**CITY OF MADISON
INTERDEPARTMENTAL
CORRESPONDENCE**

To: Plan Commission
From: Jenny Kirchgatter, Assistant Zoning Administrator
Subject: 1313 Regent Street

Proposed Use: Convert an auto repair shop into a brewpub with a reception hall and outdoor eating area.

1. PROPOSED SITE PLAN

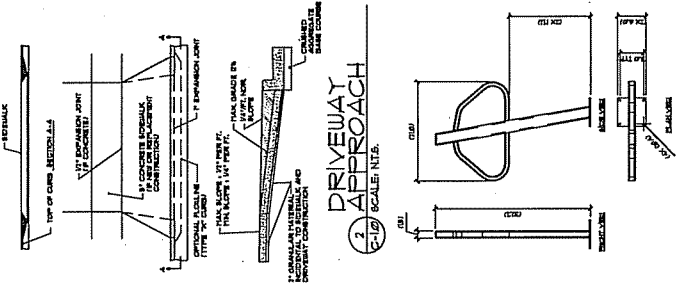
1. Meet applicable building/fire codes. The outdoor capacity shall be established. Occupancy is established by the Building Inspection Unit. Contact Building Inspection Plan Reviewer Mike VanErem at (608) 266-4559 to help facilitate this process. Submit a plan for the outdoor eating area showing the layout of tables and chairs.

2. Vehicle and bicycle parking requirements are based on the capacity of the brewpub, reception hall, and outdoor patio spaces. Submit the capacity of the brewpub, reception hall, and outdoor patio spaces with the final plan submittal to establish the vehicle and bicycle minimum parking requirements.

3. Provide a minimum of 38 bicycle parking stalls in a safe and convenient location on an impervious surface to be shown on the final plan. Clearly label and dimension the bicycle stalls and required access area. NOTE: A bike-parking stall is two feet by six feet with a five-foot access area.

mixed-use districts and residential districts. Screening shall consist of a solid wall, solid fence, or hedge with year-round foliage, between six (6) and eight (8) feet in height. Show the district boundary screening adjacent the east and west property lines abutting the residentially zoned properties on the final plans and provide a detail of the screening.

5. A refuse disposal area shall be provided. The refuse enclosure shall be screened on four (4) sides (including a gate for access) by a solid, commercial-grade wood fence, wall, or equivalent material with a minimum height of six (6) feet and not greater than eight (8) feet. Submit a detail of the trash enclosure.

8. Submit a calculation and detail plan page showing that the project meets the lot coverage requirement. The maximum lot coverage is 85%. Lot coverage is the total area of all buildings and paved areas as a percentage of the total lot area, with the exceptions of sidewalks or paved paths no wider than five (5) feet, pervious pavement, green roofs and decks.
